CALIFORNIA COASTAL COMMISSION

STAFF REPORT: REGULAR CALENDAR

APPLICATION NO.: 5-98-154

PROJECT DESCRIPTION: Paving, fencing and landscaping for the establishment of
 a 95-space surface parking lot with controlled entry on
 the waterfront at Catalina Landing.

EXHIBIT # 4

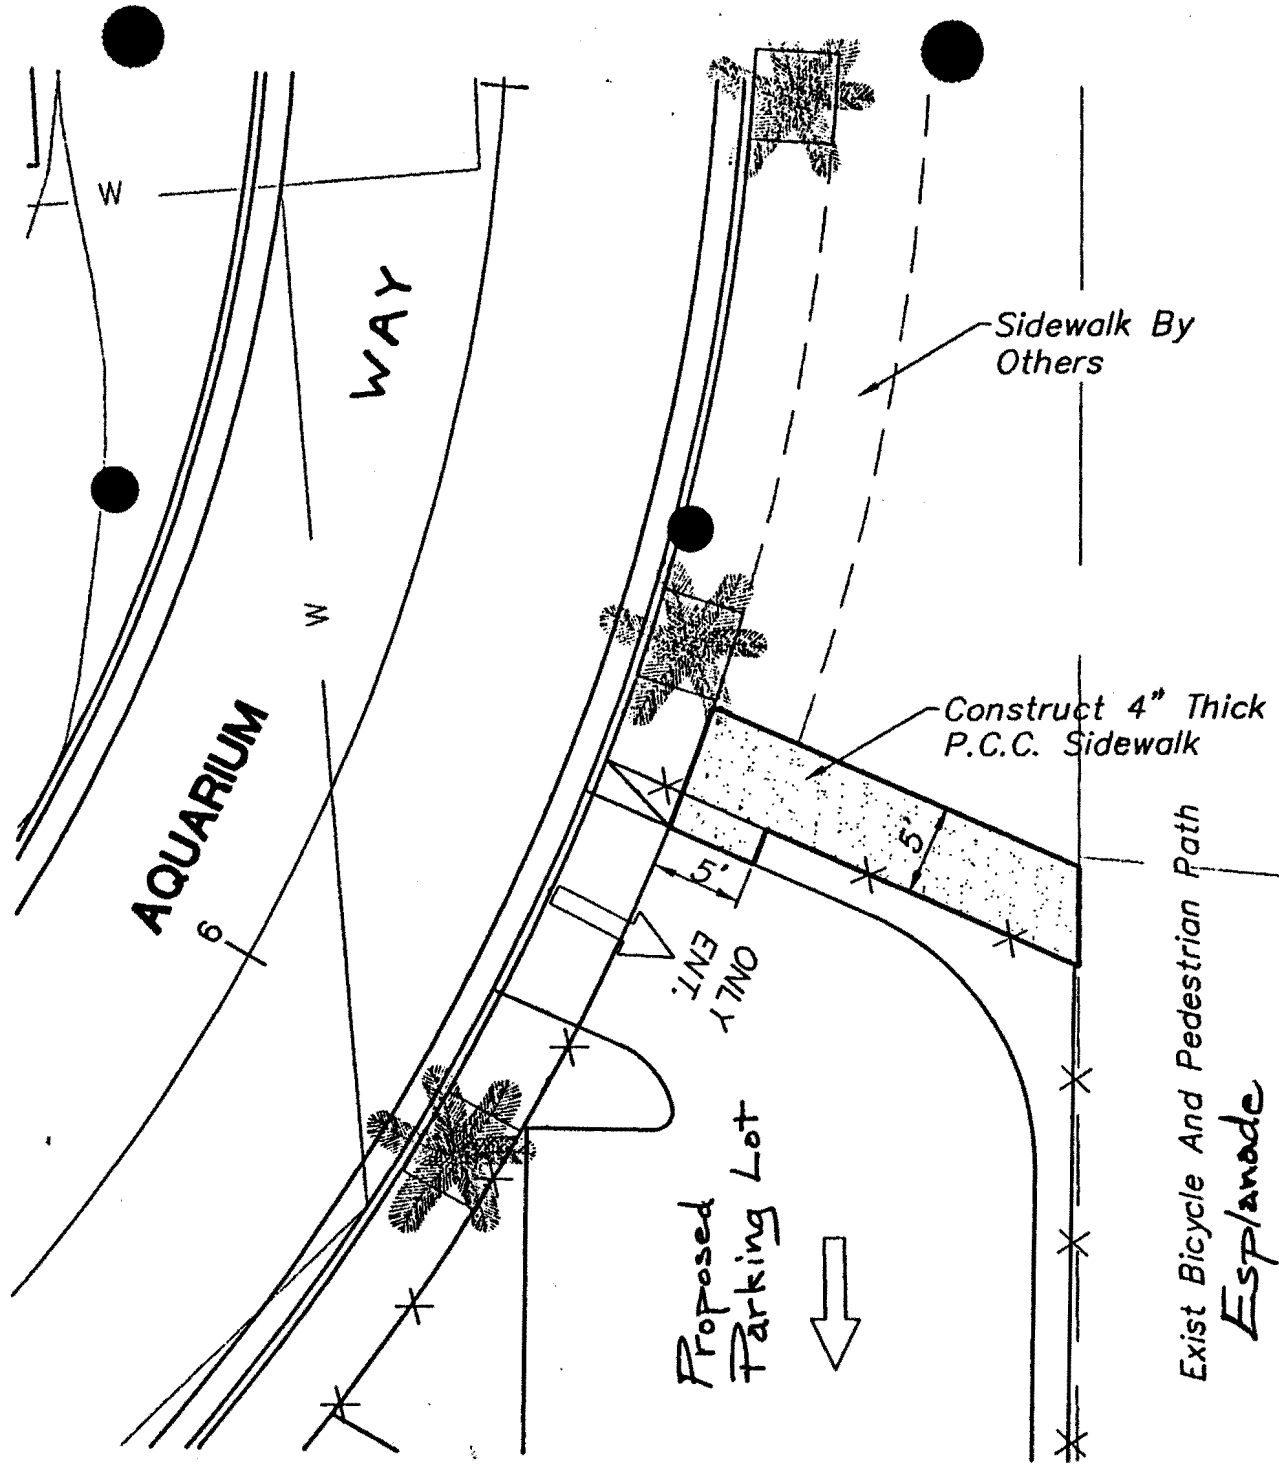
The proposed project does not provide a landscaped buffer area between the proposed parking lot and the waters of Catalina Landing. Therefore, as a condition of approval, staff recommends that the applicant submit revised plans that provide a four foot (4') wide landscaped buffer strip between the proposed pavement and the water. The City states that there is no space within the proposed parking lot site to provide any more planting area than currently proposed. The site is already very narrow for a parking lot. Therefore, the four foot wide landscaped buffer strip shall be placed in the twenty foot wide esplanade area.

The City has proposed to maintain the existing five foot wide landscaped area along Aquarium Way next to the proposed parking lot (Exhibit #4). Several palm trees are already growing in the landscaped area along the west side of Aquarium Way. A six foot high iron picket fence is proposed in the landscaped area along Aquarium Way. There is no sidewalk on this portion of Aquarium Way where it passes the project site.

Along the esplanade (west) side of the proposed parking lot, however, the City plans to erect a three foot high chain link fence without any landscaped buffer provided between the parking lot and the esplanade. As proposed by the City, the chain link fence would have climbing plant cover growing out of 1.5

square foot planters placed at twenty foot intervals along the esplanade (Exhibit #4, p.3).

In order to enhance the scenic resources of the Catalina Landing waterfront, staff recommends that the City provide a four foot wide landscaped buffer between the proposed parking lot and the public accessway that runs along the esplanade. A landscaped buffer would soften the visual impact of the proposed pavement and fencing.

- A. Public Access on Catalina Landing Esplanade. All pavement and fencing for the proposed parking lot shall be set back a minimum of twenty feet (20') from the top of the Catalina Landing seawall. The existing twenty foot (20') wide Catalina Landing Esplanade shall be maintained and improved within the required twenty foot (20') setback area as follows:

1. A four foot (4') wide landscaped strip shall be provided on the inland edge of the esplanade along the western and southern boundaries of the proposed parking lot site. A landscape plan shall identify the types and locations of trees and shrubs to be planted in the required four foot (4') wide landscaped strip located on the esplanade next the proposed parking lot.

2. A sixteen foot (16') wide public accessway shall be maintained on the esplanade between the four foot (4') wide landscaped strip and the top of the Catalina Landing seawall. The sixteen foot (16') wide public accessway shall be striped and signed to identify the existing Regional Bicycle Route and pedestrian walkway on the esplanade.

- C. Aquarium Way Landscaping. A five foot (5') wide landscaped strip shall be provided between the proposed parking lot and Aquarium Way as shown on the proposed plans submitted with Coastal Development Permit application 5-98-154 on April 17, 1998 (Exhibit #4).

- D. Fence Heights. The height of the fence which separates the proposed parking lot from the twenty foot (20') wide Catalina Landing Esplanade shall not extend more than 3.5 feet (42") above the level of the existing esplanade. The height of the fence which separates the proposed parking lot from Aquarium Way shall not extend more than six feet (6') above the level of Aquarium Way. No barbed wire, razor wire or other attachment shall be added to any fence without prior review and approval by the Coastal Commission in the form of a permit amendment.
